ADDENDUM NUMBER TWO

**HCPS WAREHOUSE BUILDING
HENDERSON COUNTY/HENDERSON COUNTY PUBLIC SCHOOLS**

MLA PROJECT NUMBER: 21010

DATE OF ISSUE: August 25, 2021

SITE PLAN

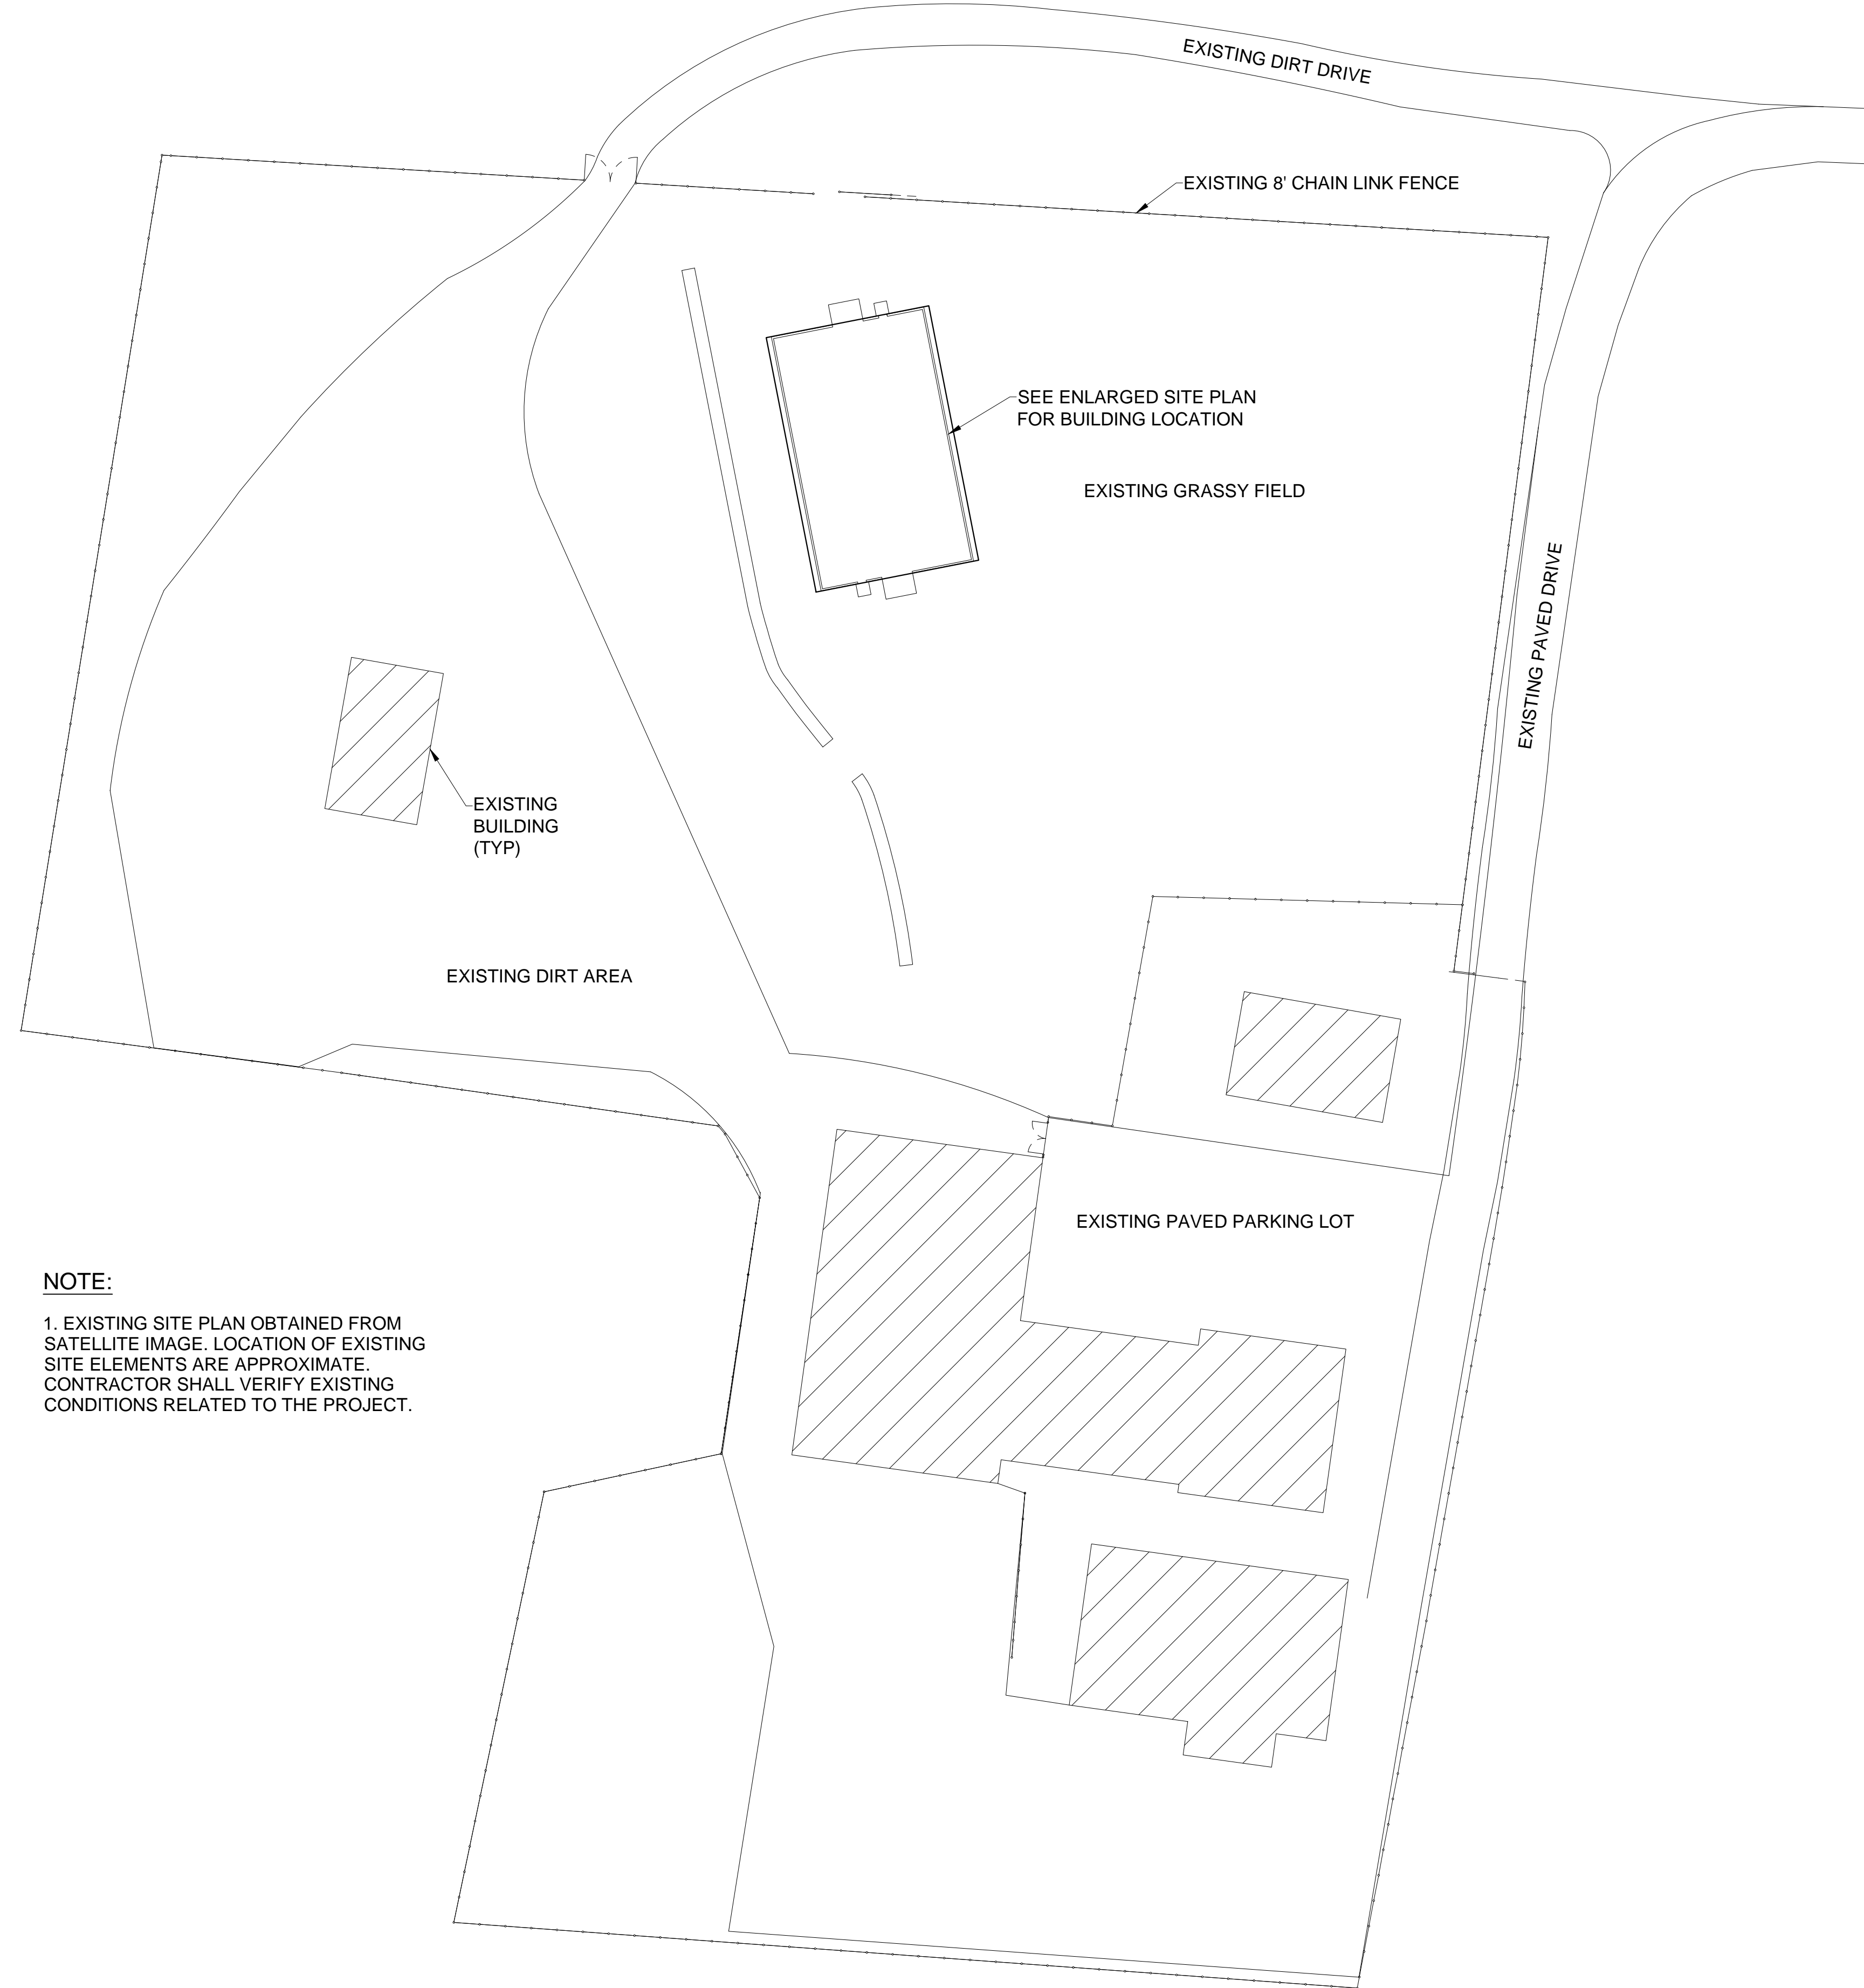
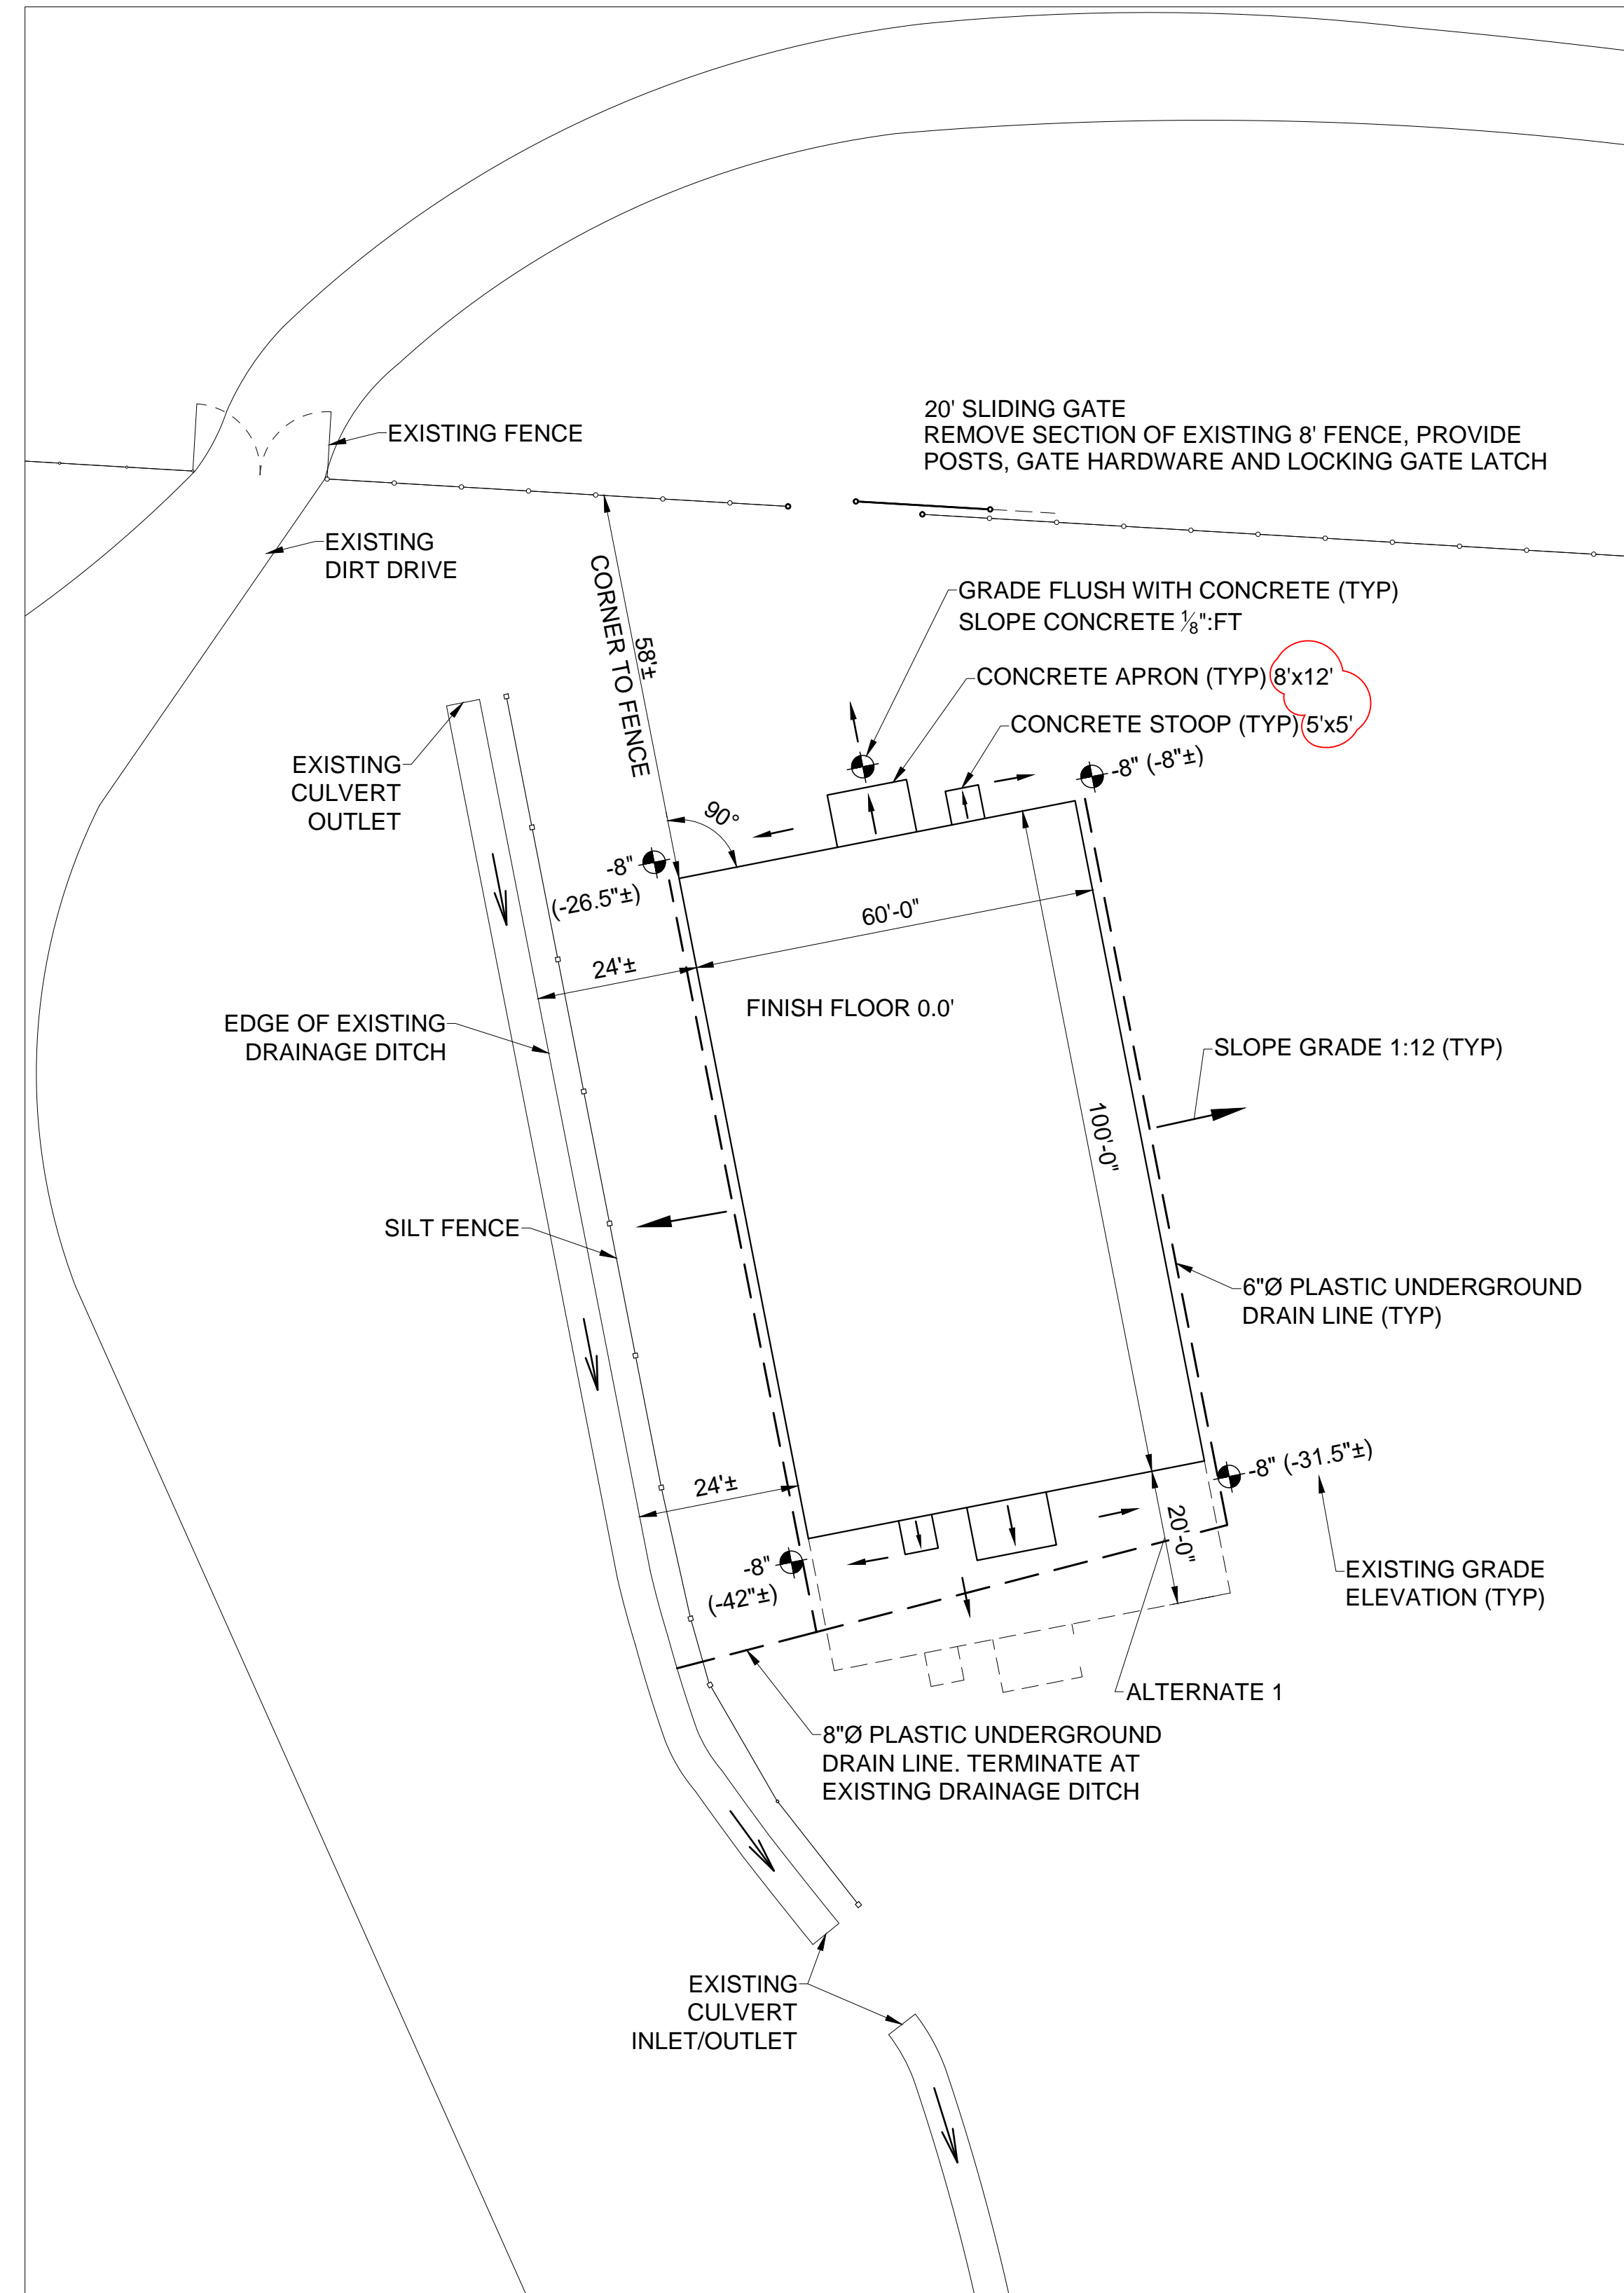
1. C101:
 - HDPE pipe acceptable for underground drain lines
 - Dirt for fill is available on site. A unit price is added for fill dirt if off site fill dirt is required.

- Top soil removed for clearing is acceptable for outside fill
 - Exterior concrete clarifications and note
2. A101/ A201:
 - The soffit is deleted from the building
 - The ridge vent is deleted from the building
 - The passage door location is corrected on Alternate 1 plan
 - Concrete floor stone base thickness changed to 4"
 3. 4-5/A201: revise 6 mil VB to 10 mil VB
 4. E1/E2/ E3/ E4:
 - An exhaust fan is added to the south louvers and specified on Lighting Fixture Schedule
 - The passage door locations are corrected on Alternate 1 plan
 - The meter box and panel are re-located to the south corner wall
 - Panel A is revised to include EF's
